BAR Meeting
September 24, 2008

ISSUE: Addition and Alterations
APPLICANT: James and DeShuna Spencer
LOCATION: 229 North West Street
ZONE: RB/Residential

BAR CASE #2008-0148, 0149 2/27/2008

Figure 3 Proposed East Elevation

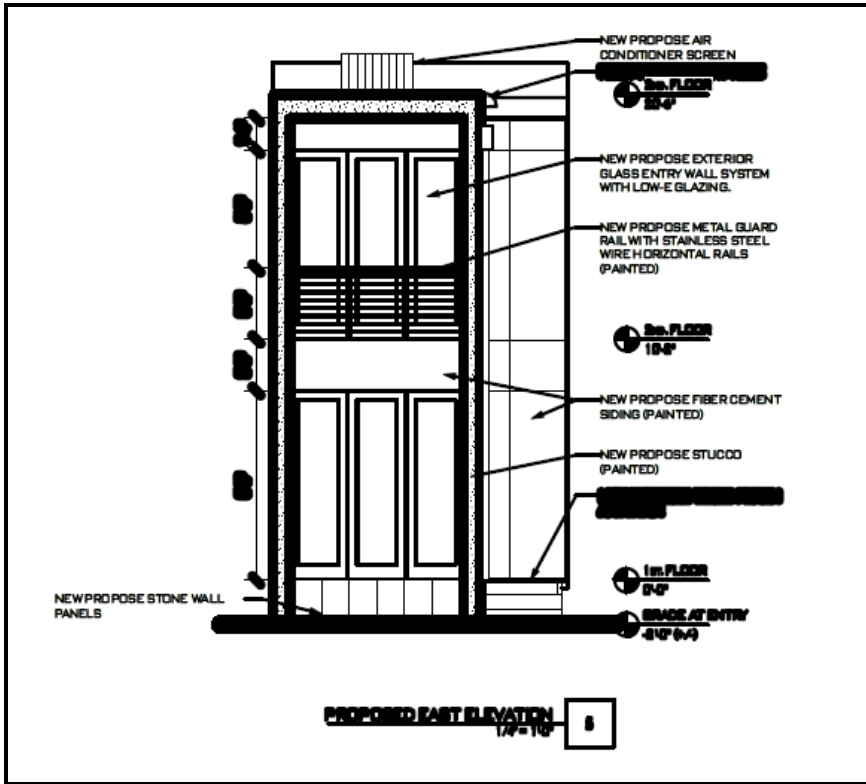
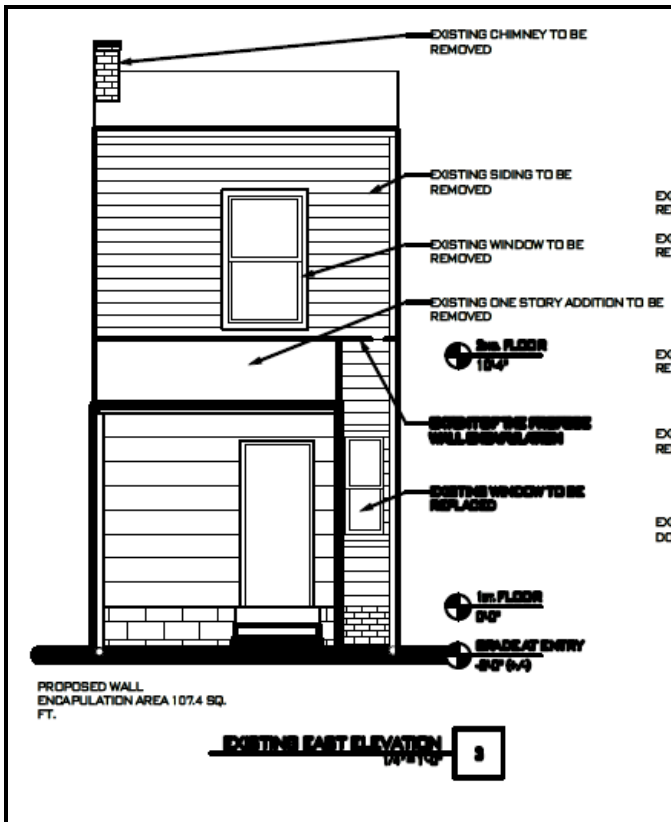
On the first floor of the rear (east) elevation, there will be three 8' fixed windows over stone wall panels. On the second floor, three full-light French doors are proposed and a metal guard rail with stainless steel wire horizontal rails. This entire two story projection is proposed to be framed by stucco. To the north of this projection is a 4' setback two stories in height which contains an entrance to the new addition. The setback will be clad with fiber cement panels. There will be a small wood deck with a stainless steel wire railing leading to the rear entrance. All windows and doors on the addition, as well as the replacement windows on the front façade, are proposed to be double-insulated and manufactured by Jeld-Wen.

Figure 5 Proposed West Elevation

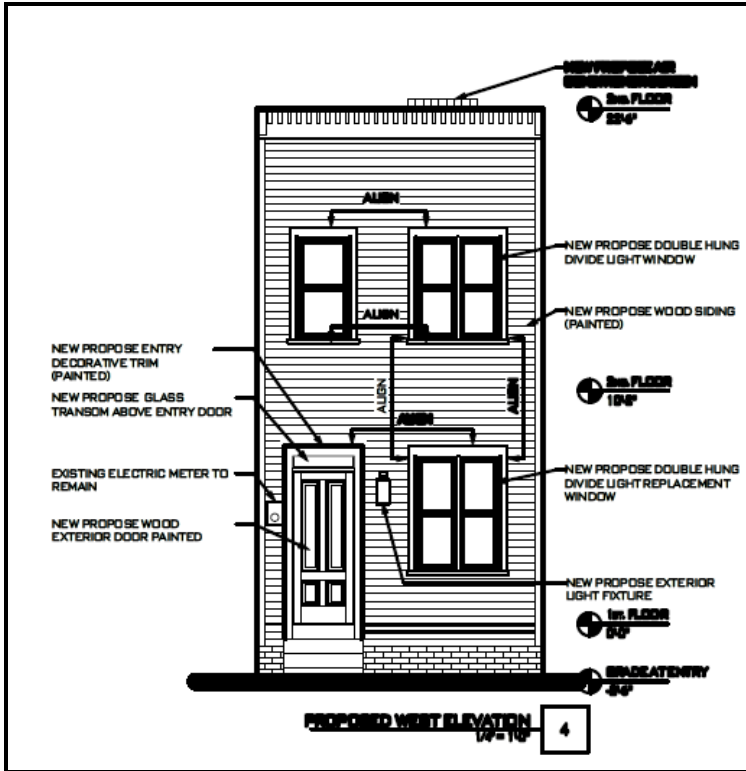
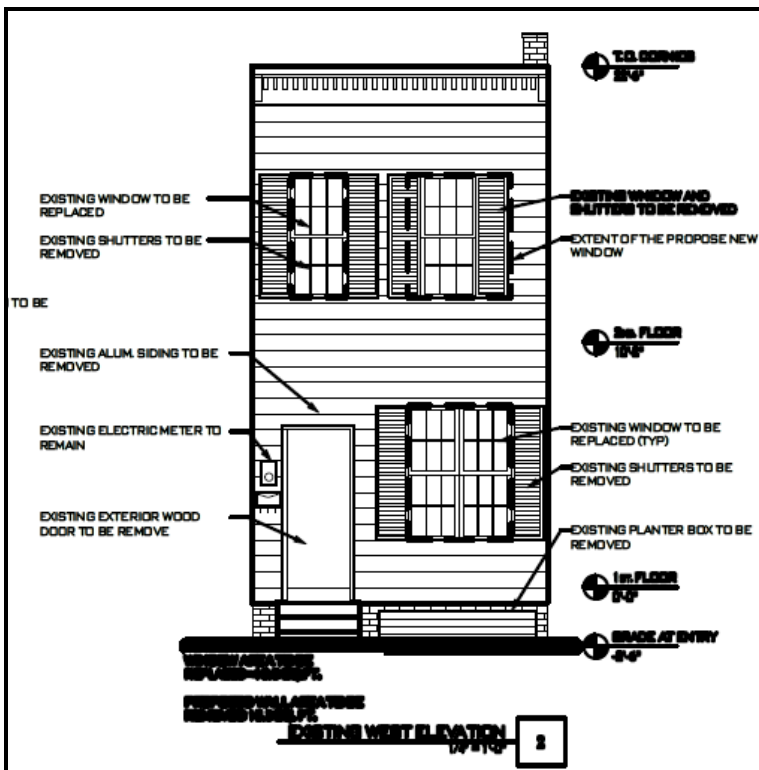
Staff would prefer to see the applicant maintain the two single window openings on the second floor rather than enlarging the southernmost opening on the second floor for a pair of windows. Staff believes that historically each of the five townhouses on this row would have had two single windows on the second floor. All of the original townhouses have been modified over the years and Staff agrees with the applicant that the windows on 229 North West Street appear to be offset and may well not be original openings. Nevertheless, Staff believes that the existing double-hung windows on the second floor should be retained.

The *Design Guidelines* recommend that all windows on historic properties be single glazed (one pane of glass) with true divided lights. Although the Board sometimes permits the use of double-insulated (two panes of glass) windows on less visible elevations, and on new construction, Staff typically recommends that at the very least the front windows be single glazed. The Board recently approved double-insulated two-over-two wood windows on the front façade of the adjacent townhouse at 227 North West Street. Should the Board approve double-insulated windows in this particular case, the impact of the double glazing will be mitigated by the lack of muntins and spacer bars dividing the glass.

S-1 Double-hung paired windows at first and second floor front façade be replaced by single, double-hung, two-over-two wood windows to reflect original fenestration scheme.

1. That there be no parking on the property;
2. That the new windows on the front façade be double-hung, single-glazed wood windows;
3. That the southernmost window opening on the second floor be retained and not enlarged;

4. That the applicant work with Staff to evaluate any historic wood siding underneath the aluminum siding on the front elevation and whether it can be retained and repaired;

Figure 7 Proposed North Elevation

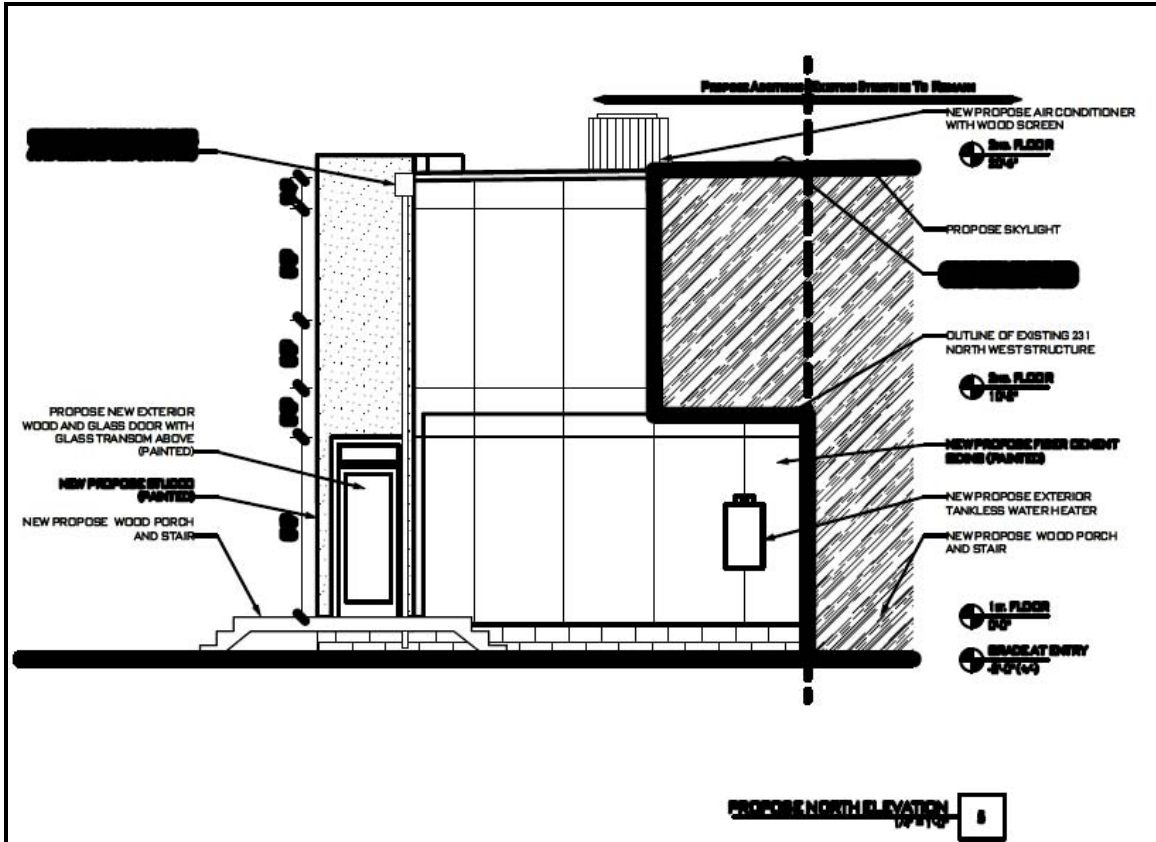
On the north side, the applicant's addition will project roughly 11' beyond the rear of the neighbor's two story addition at 231 North West Street. The first floor of the adjacent addition is also set back on the first floor. The north elevation will be clad with fiber cement panels.

The applicant is proposing to use fiber cement panels on the addition. The Board has adopted the following policy with respect to the fiber cement siding, and Staff believes the same standards should apply to the proposed panels:

1. That fiber cement siding not be installed on an historic structure;
2. That historic materials should not be removed to install fiber cement siding;
3. That fiber cement siding replace other artificial or composite siding;
4. That the nails not show in the installation of the siding; and,
5. That smooth siding be installed.
6. That BAR Staff may administratively approve the installation of fiber cement siding on *non-historic* buildings (those constructed in 1975 or later).

5. That, if the condition of the siding is poor, the applicant should install the same type of wood siding that was originally on the house; and,
6. That the fiber cement panels be used only on the addition;

7. That smooth fiber cement panels be used;
8. That the nails not show in the installation of the panels;
9. That the wood screen fence around the rooftop HVAC be stained or painted; and,
